P 44417

SEWAGE DISPOSAL SYSTEM

A REPAIR

SUBDIVISION \_\_\_\_\_ ROAD 1320 Henryton Road LOT \_\_\_\_\_

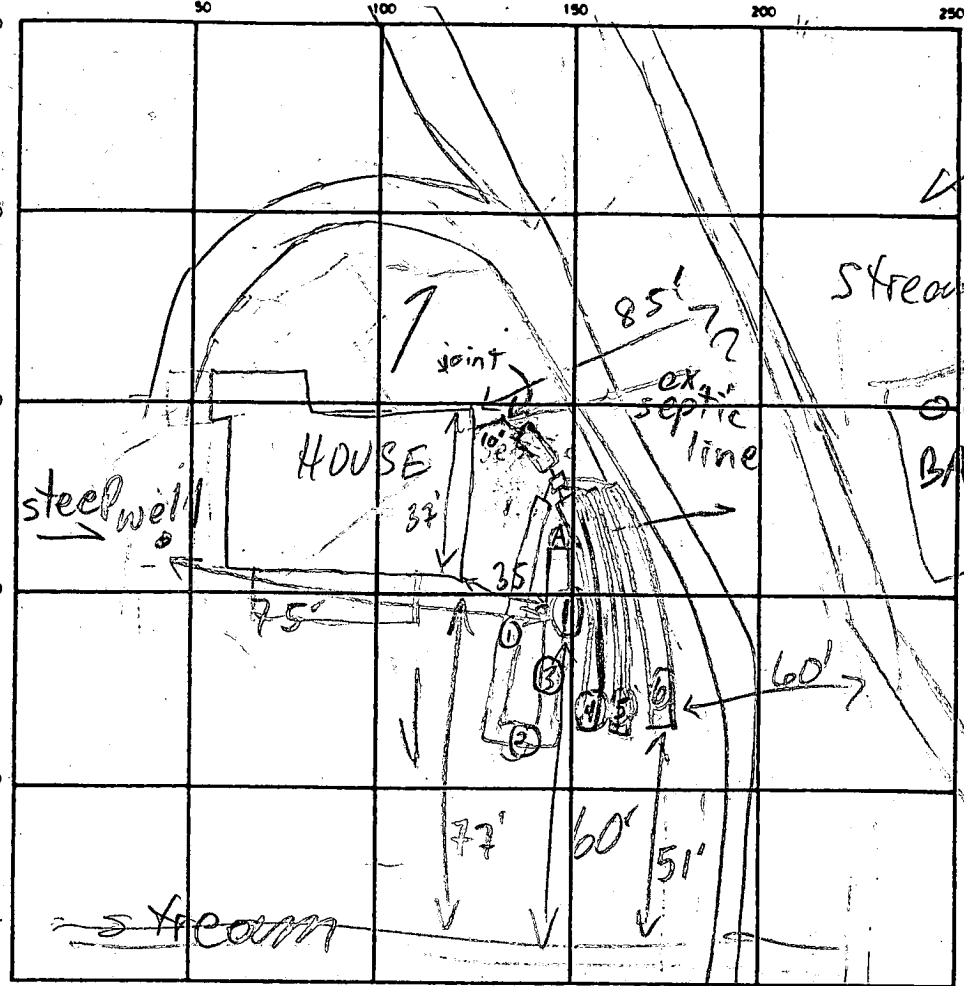
REPAIR. CONVENTIONAL SYS NOT POSS - INSTALL 1000 OR 1500 GAL SEPTIC TANK, FINAL DETERMINATION OF DISPOSAL SYSTEM AT TIME OF S.T. INSTALLATION MR 2/9/90 180 Ø BR INLET 1 1/2' BOTTOM 3' 5 TRENCHES 47'± EA. MR

① @ 4 1/2  
 11:04  
 DID NOT  
 PERC IN 60 MIN  
 WATER AT 6"  
 2000 frags  
 thruout

① @ 2 1/2  
 200 first " in 35 min

intermittent  
 org. & brn  
 clay loam w/  
 brn sandy  
 loam  
 ↓  
 6' SATURATED  
 ZONE  
 w/ MOTTLING  
 GREY &  
 ORG MOTTLES  
 HIGH MICA  
 10' STANDING  
 WATER  
 11"

REMARKS 2/9/90 WATER AT BOT. OF S.T. EXCAVATION (6 1/2") S.T.  
AS HIGH AS POSS. MR 2/12/90 OK TO CONTINUE W/  
TRENCHES MR 2/13/90 OK TO COVER ALL MR

2/9/90 REPAIR CONDITIONS VERY LIMITED. IF UNSUCCESSFUL, RESORT TO BUILDING TANK. E.W.
